UNITED STATES PATENT AND TRADEMARK OFFICE

10/577,067

| Office Action Summary | Application No. 10/577,067 | Applicant(s) AMANO, RYUICHIRO | |

DETAILED ACTION

【図6】

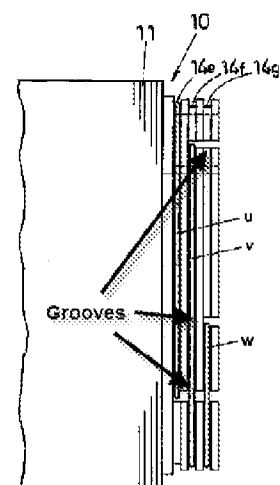
With regard to claim 4, the combination of Miyawaki and Fujita discloses the stator according to claim 2, as stated above, wherein each of the lead-out guide portions [14a/b/c] comprises a groove (see annotated figure 6 of Miyawaki) provided adjacent to a periphery of a corresponding one of the first and second tooth winding portions [13a-13f] (see figure 3 of Miyawaki).

With regard to claim 6, the combination of Miyawaki and Fujita discloses the stator according to claim 4, as stated above, wherein the grooves of the lead out guide portions [14a/b/c] are circumferentially spaced from each other (figure 6 of Miyawaki).
